### FINDINGS INTO THE DEATH OF DAVID R GREEN

# Intersection of Spences Road and Numurkah Road, Katunga, Victoria

## Existing Conditions Road Safety Audit

Final Report – 28/05/2019

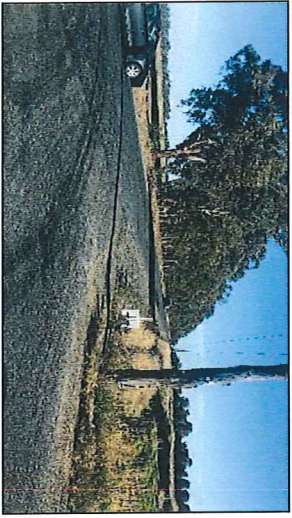
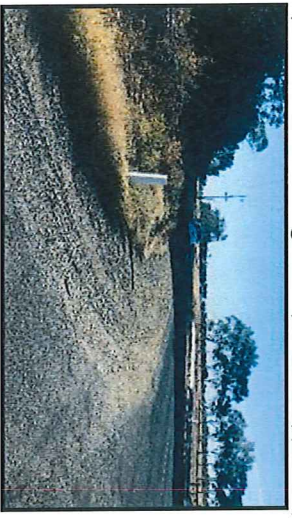
1.2.2	<p>There is a line of trees with low-hanging limbs that may restrict the vision of drivers on the eastern approach when looking south along Numurkah Road.</p> <p>This could obscure a vehicle on the Numurkah Road southern approach from the view of a vehicle waiting to enter the intersection from the Spences Road eastern approach and could result in a collision between the two vehicles at the intersection.</p> 	Trim/remove tree limbs on the eastern side of Numurkah Road (south of Spences Road) to ensure sightlines are maintained.	NOTE ONLY

No	Audit Findings	Audit Recommendations	Risk Rating	Accept: Yes / No	Client Response Reasons / Comments
1.2.2 Cont.	<p>It should be noted that sightlines are in excess of 300 m looking north from the eastern approach at 5.0 m set back from the edge of seal on Numurkah Road.</p> <p>This is the desirable location from which to assess Safe Intersection Sight Distance (SISD) as specified in Figure 3.2 of AGRD4A.</p> <p>It is concluded that the minimum SISD criterion is satisfied.</p> <p>However, to further ameliorate the risk of collisions at the intersection, some vegetation clearing is recommended.</p>	Refer above	Refer above

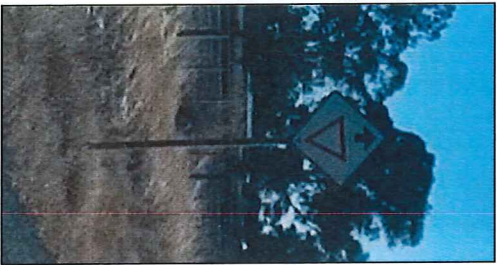
1.2.4	<p>There is a power pole on the south west corner of the intersection, however this does not impact the vision of drivers on the eastern approach when looking south along Numurkah Road.</p> <p>It should be noted that sightlines are in excess of 300 m looking south from the western approach at 5.0 m set back from the edge of seal on Numurkah Road.</p>	No action required	NOTE ONLY

No	Audit Findings	Audit Recommendations	Risk Rating	Client Response Accept: Yes / No Reasons / Comments
1.2.4 Cont.	 <p>It is concluded that the minimum SISD criterion is satisfied</p>	Refer above	Refer above

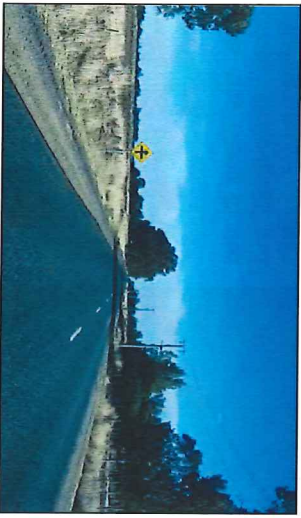
1.2.5	<p>The Spences Road western approach to Numurkah Road is STOP sign controlled.</p> <p>For a posted speed limit on the major road (Numurkah Road) of 100km/h the sight distance threshold along the major road (at 3.0m from the edge of the through lane) is 95m, below which a Stop sign should be used.</p> <p>The sightlines for Numurkah Road are more than 300m in both directions for the western approach indicating Give Way to be the appropriate control.</p> <p>The sight distance is greater than that shown in Figure 2.2 and therefore, a STOP sign is not required.</p>	Review the appropriateness of the STOP sign on the Spences Road west approach with a view to replacing it with a GIVE WAY sign, and markings.	NOTE ONLY

No	Audit Findings	Audit Recommendations	Risk Rating	Client Response Accept: Yes / No Reasons / Comments	
1.2.5 Cont.	<p>Spences Road looking south (western approach).</p>  <p>Spences Road looking north (western approach).</p>  <p>It should be noted that the use of STOP signs where poor sight distance is not a factor can lead to driver non-compliance, and a lack of credibility of STOP signs where they are appropriate.</p>	Refer above	Refer above

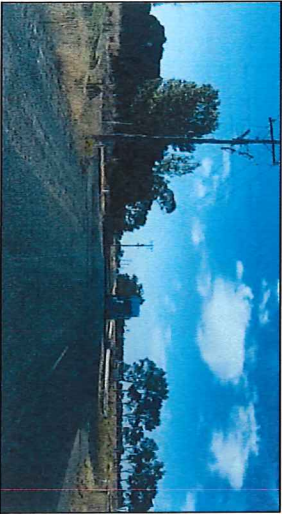
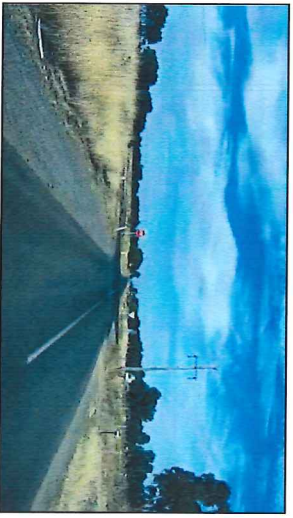
No	Audit Findings	Audit Recommendations	Risk Rating	Client Response Accept: Yes / No Reasons / Comments	
1.2.6	<p>The STATCON line marking at the intersection is faded and does not delineate the intersection. This makes it hard to see when approaching the intersection from both approaches on Spences Road.</p> <p>This could result in a vehicle on Spences Road misjudging the intersection and overshooting, potentially colliding with through traffic on Numurkah Road.</p> 	<p>Refresh all the STATCON linemarking at the intersection following the review noted in Item 1.2.4.</p>	<p>Likelihood: Improbable Severity: Serious Risk Rating: <b>MEDIUM</b></p>

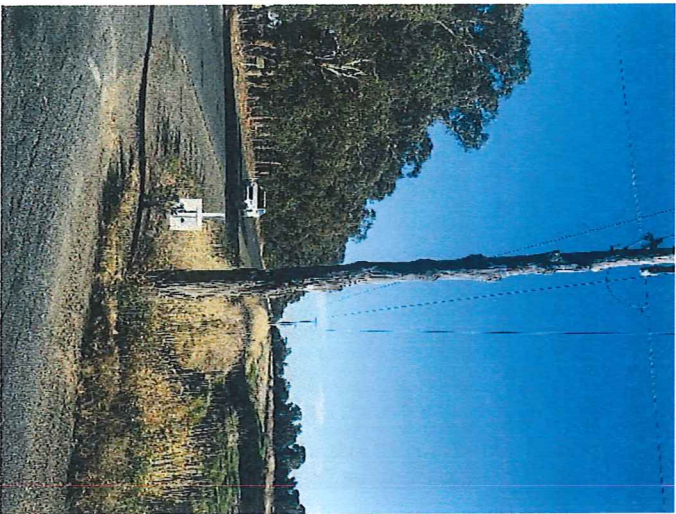
No	Audit Findings	Audit Recommendations	Risk Rating	Client Response Accept: Yes / No Reasons / Comments	
1.3.3	<p>Crossroad warning signs are present on both major approaches and are in good condition.</p> <p>Northern Approach</p>  <p>Southern Approach</p>  <p>No further action required.</p>	No action required	NOTE ONLY

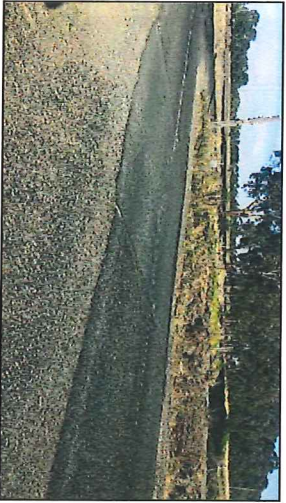
No	Audit Findings	Audit Recommendations	Risk Rating	Client Response Accept: Yes / No Reasons / Comments	
1.4.2 Cont.	<p>This could result in a vehicle on Spences Road misjudging the intersection and overshooting, potentially colliding with through traffic on Numurkah Road.</p> 	Refer above	Refer above		
1.4.3	<p>Near the intersection along both Spencer Road and Numurkah Road, guideposts are only installed to mark cross culverts and other roadside structures.</p>  <p>Guide posts are used to mark the edge of the road formation in the absence of other features, such as edgelines, guard fence or bridge rail.</p>	Consider installing additional guideposts on the approaches to the Spencer Road/Numurkah Road intersection to enhance delineation of the intersection.	<p>Likelihood: Improbable Severity: Minor Risk Rating: LOW</p>

No	Audit Findings	Audit Recommendations	Risk Rating	Client Response Accept: Yes / No Reasons / Comments	
1.4.3 Cont.	Guideposts delineate the road edge and assist the road user by indicating the alignment of the road ahead and under some circumstances, by providing a gauge with which to assess available sight distance.	Refer above	Refer above		
<b>1.5 Crash Barrier and Clear Zones</b>					
1.5.1	Located near the Stop sign on the western approach to Nurnurkah Road is an obsolete (old style) guidepost. This is not considered frangible and present a hazard to an errant vehicle on the western approach to the intersection.	Remove the obsolete guidepost and replace it with a frangible guidepost as required.	Likelihood: Improbable Severity: Minor Risk Rating: LOW
